CITY OF SOUTH ST. PAUL MEETING AGENDA

PLANNING COMMISSION

PLANNING COMMISSION AGENDA REPORT

Site Plan Review and Conditional Use Permits for AVR LLC Concrete Batch Plant Project at 400 Richmond Street East

SITE DIMENSION PLAN

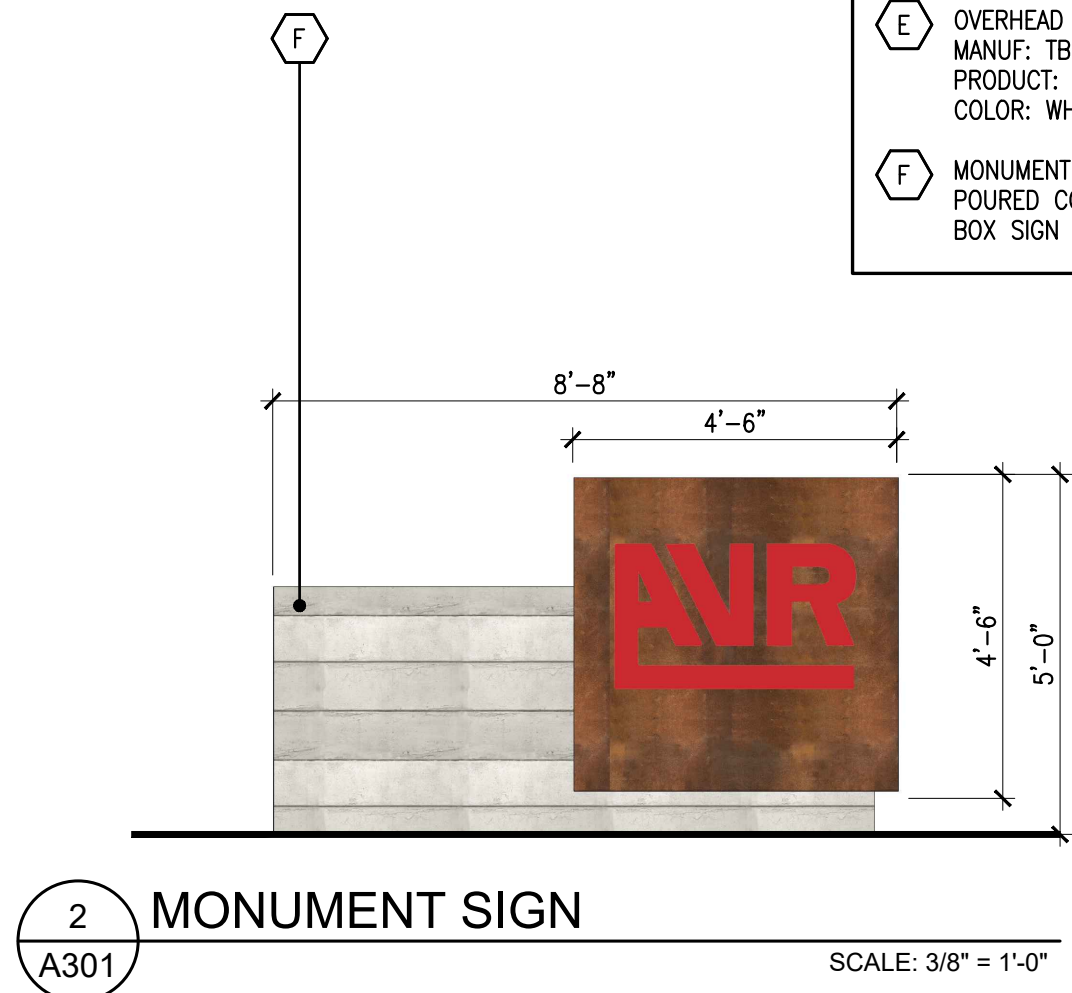
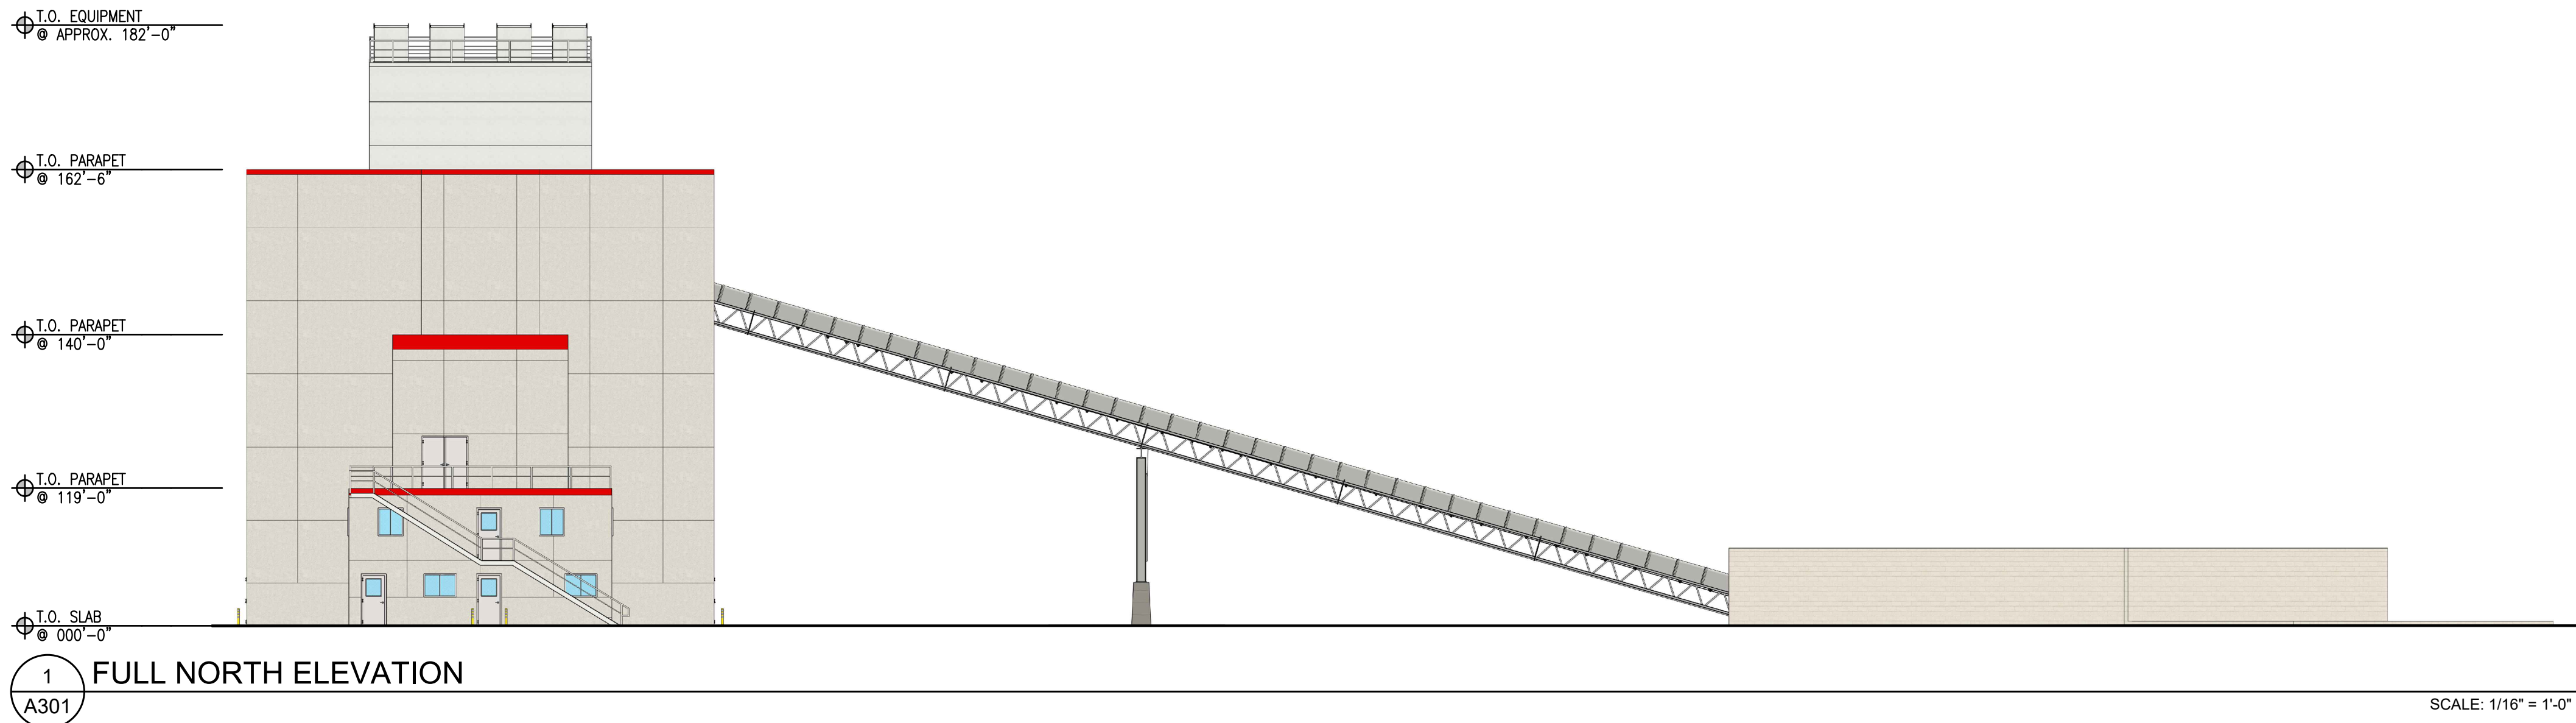
1. Applicant shall provide details for the pavement sections. The notes for the pavement hatching in the legend on sheet C400 state “SEE DETAILS FOR SECTION”. No such details were provided in the plan set.

ATTACHMENT 6 BUILDING ELEVATIONS

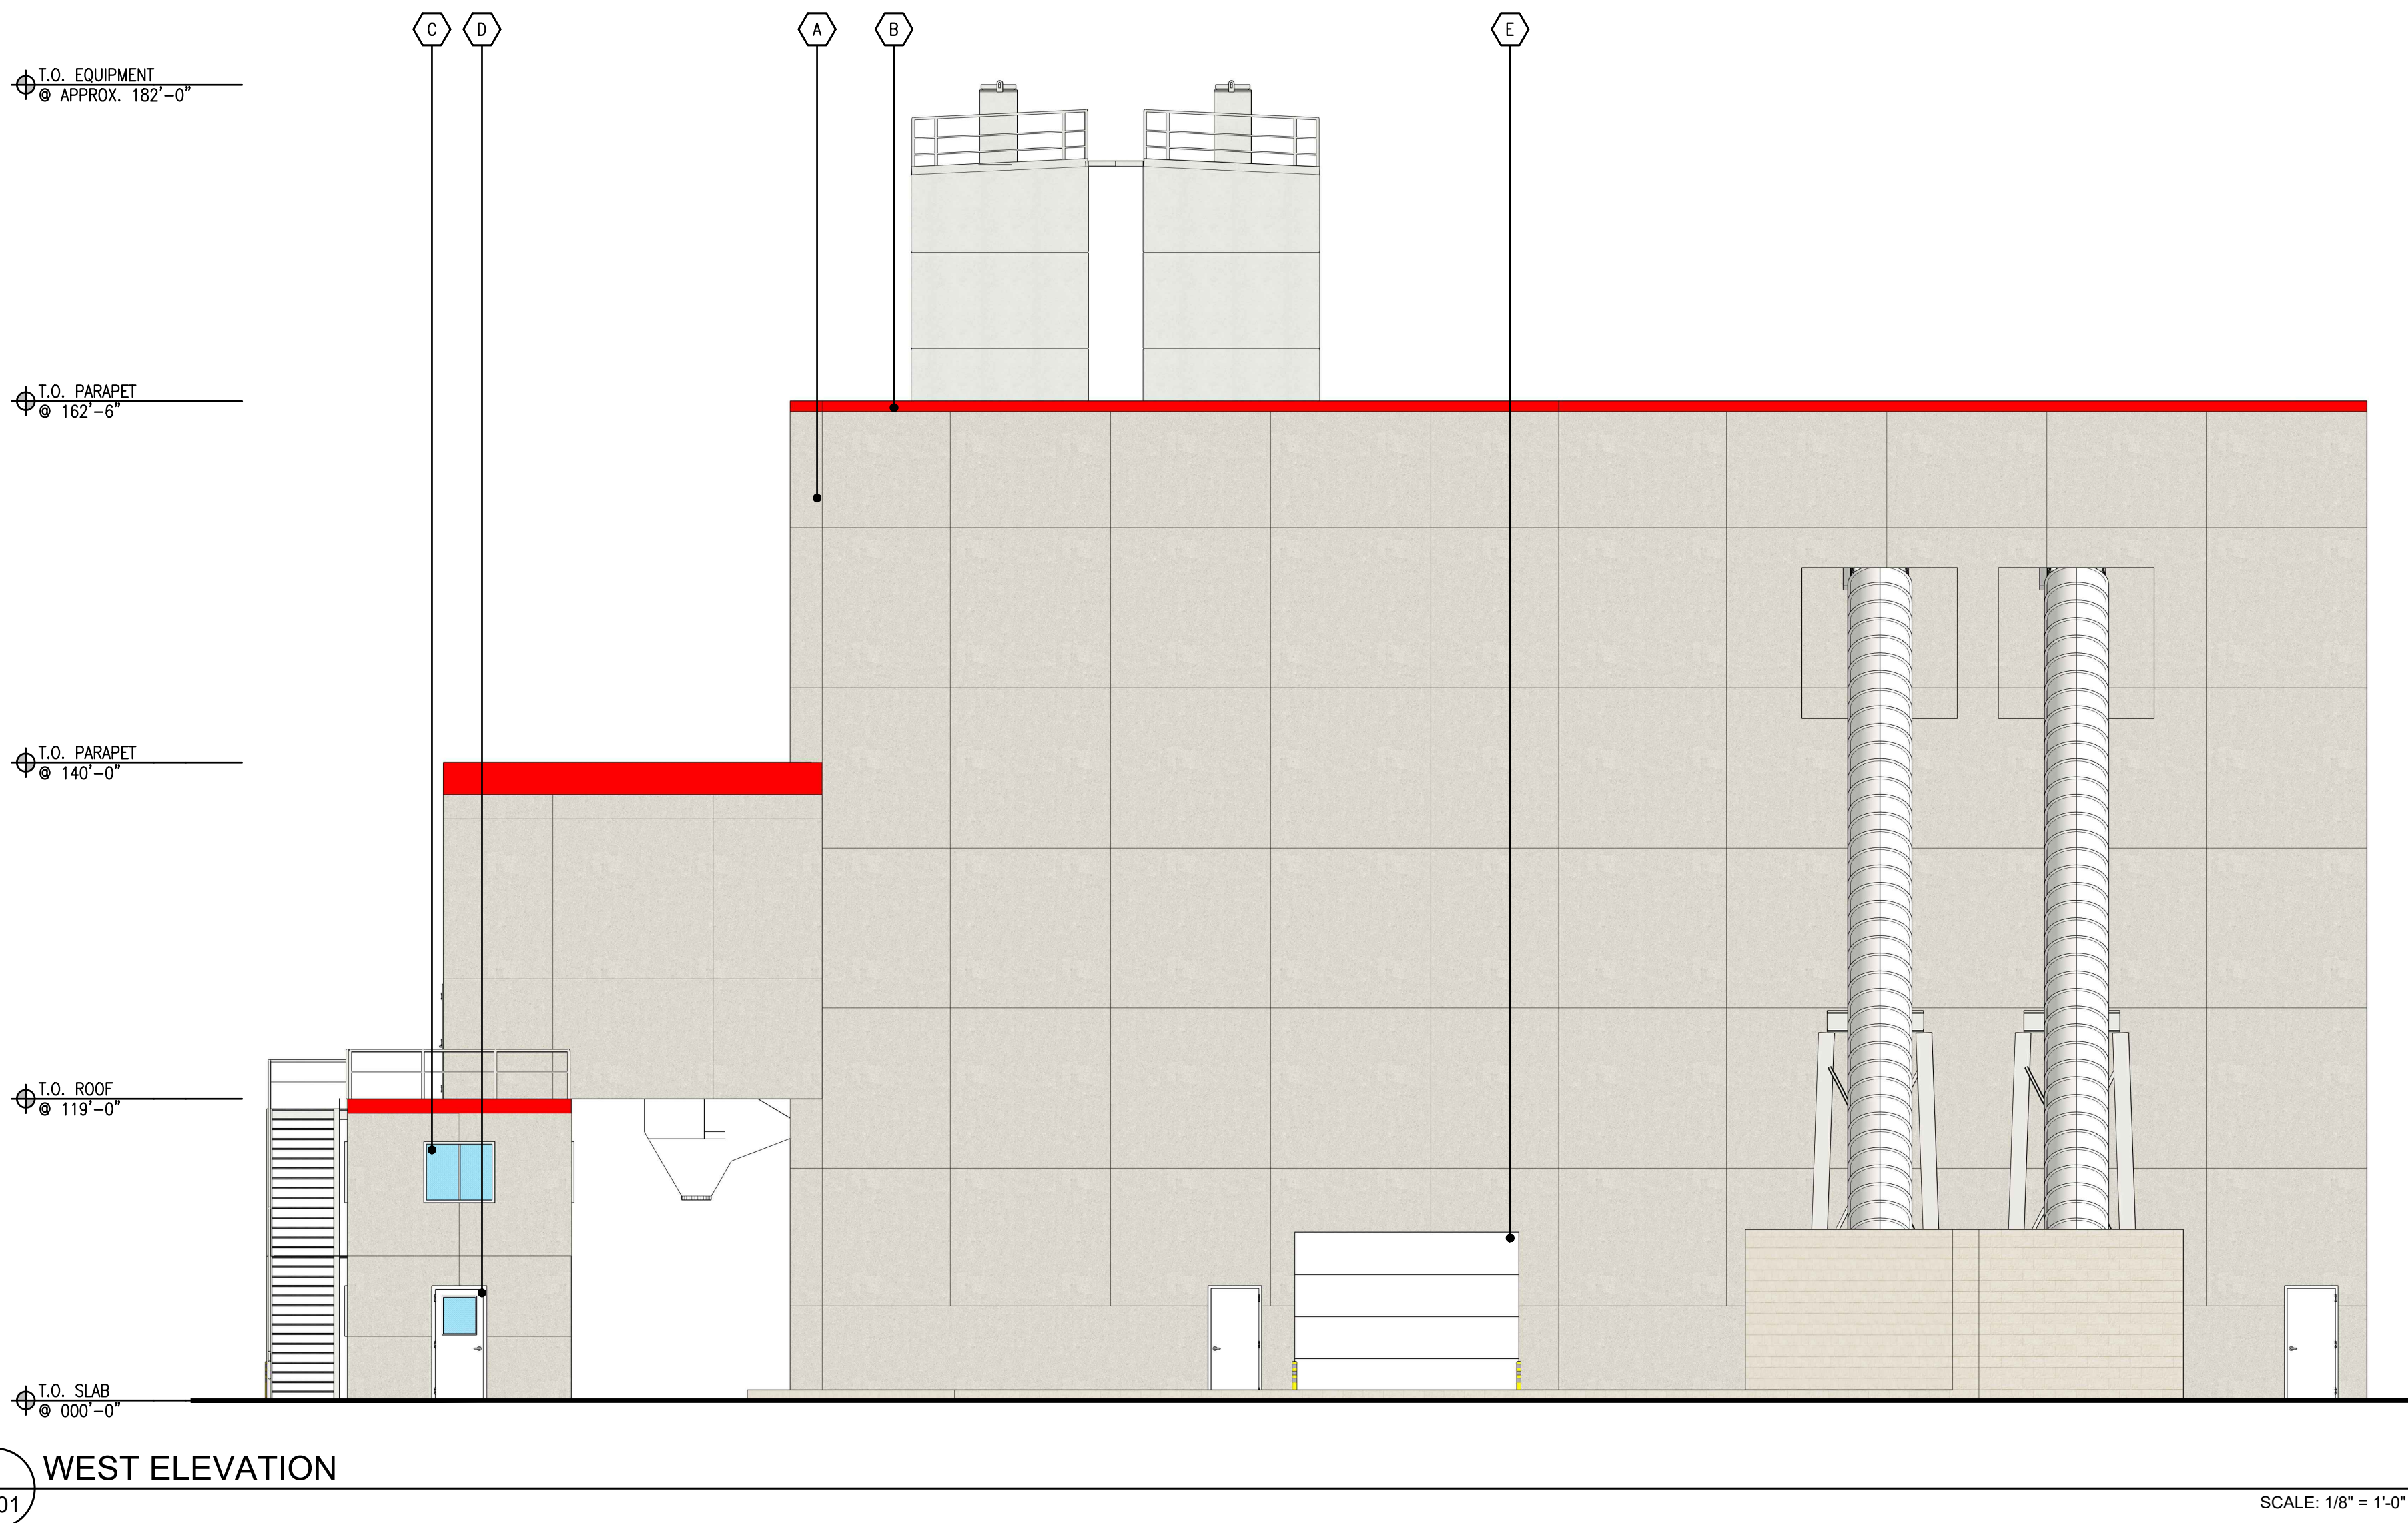
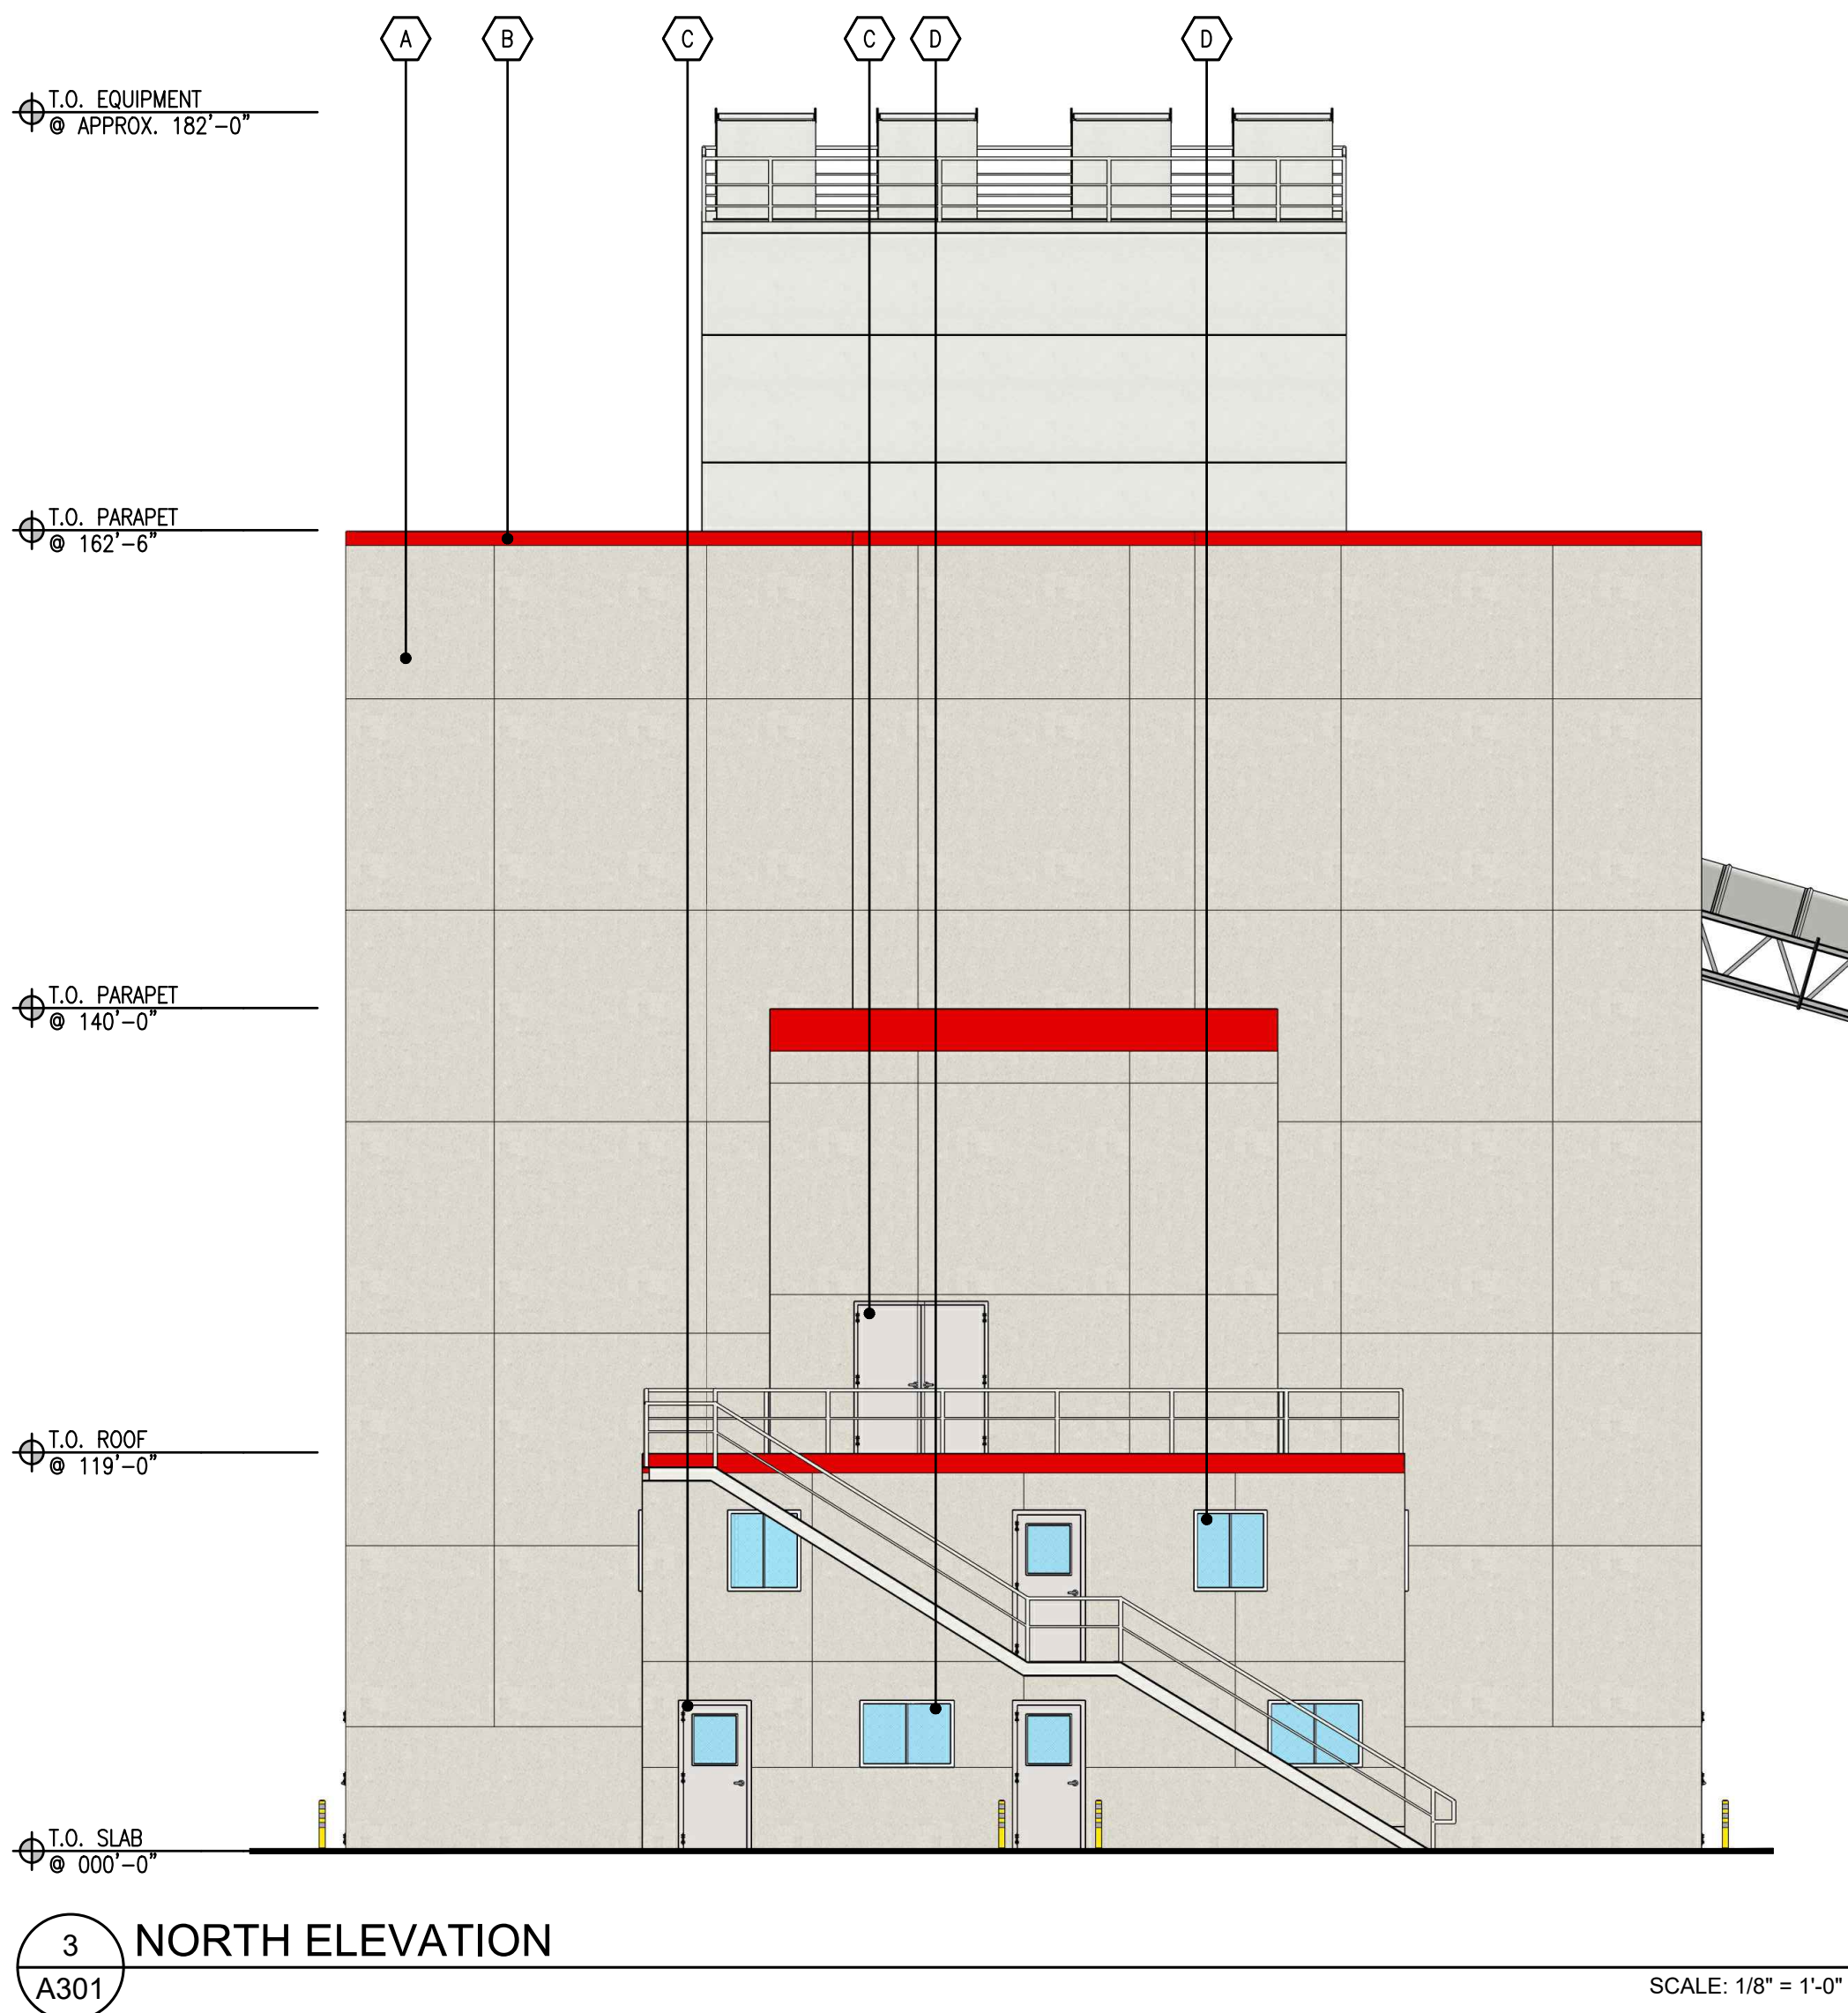
The City Code does not list “insulated concrete forms” in any of its building material classifications. The Applicant is asserting that it will be of a similar quality as traditional stucco and should be considered a Class II material. Even if the Planning Commission and City Council feel that it is more similar to synthetic stucco (EIFS), it would still be allowed because this area allows Class III materials. City Staff is comfortable supporting the use of insulated concrete forms for the concrete batch plant’s exterior.

concrete forms with a stucco finish are the equivalent of a Class II or Class III material, as required by Section 118-9. The concrete batch plant building may be built with this material in compliance with the approved plans.
